HISTORIC AND DESIGN REVIEW COMMISSION

HDRC CASE NO: 2022-478
COMMON NAME: ROW at Frio & W Commerce
ZONING: UZROW, H
CITY COUNCIL DIST.: 5
DISTRICT: Cattleman Square Historic District
APPLICANT: Bianca Alvarez/Department of Arts & Culture, City of San Antonio
OWNER: Bianca Alvarez/Department of Arts & Culture, City of San Antonio
TYPE OF WORK: Installation of public art
APPLICATION RECEIVED: January 06, 2023
60-DAY REVIEW: Not applicable due to City Council Emergency Orders
CASE MANAGER: Rachel Rettaliata
REQUEST:

The applicant is requesting a Certificate of Appropriateness for approval to permanently install two public art sculptures within Cattleman Square.

Historic and Design Review Commission
Design Review Committee Report

Final Design – Approved by San Antonio Arts Commission & Public Art Committee

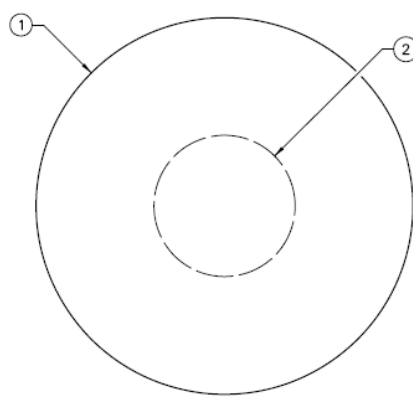
RM: This location says "Gateway to the Westside" to me. Seeing the overlay of La Prensa gives it historic importance. I don't necessarily get the top, I don't think it is unique to the west side. I think the historical reference to La Prensa saved this art piece. The west side has produced some important artists, including the artist for these works.

MS: Regarding the content of the artwork, what is it about this top that distinguishes it from any other top? How is it specific to its gateway and what lies beyond.

MS: I wanted to see what would differentiate this top from a Central European one. I will rest comfortably knowing that many of these decisions came from community engagement and the artist's plans.

MS: Would a slightly taller base help to distinguish it from surrounding structures? I'm thinking also of people sitting on it and how does that play into the mission of how we interact with our artwork?

LG: I have an opinion similar to Roland's, especially concerning the top. How much feedback did you get? Was there high turnout?

RM: I have a question about lighting, will there be lighting in the base?

BA: In conversations with the artist, his body of work does include child play, family scenes, community. In his compositions, we often see playfulness in the center of his interactions, including these toys like the trompo. This was a toy that he played with as a child. Wooden

VR: The bases and foundations were in the hands of the experts in PWD, the base is assigned by them based on a lot of consideration.

BA: For the survey alone, we had 67 responses. The survey was open for 2 months Feb-April 2021. Responses were published on the Public Arts website. Some of the themes included seeing objects like pinatas, cascarones, and trompo. So, the trompo made the cut specifically.

VR: No, we will use the lighting existing on the streets, it will be changing due to a PWD project. We do not have funding for lighting.
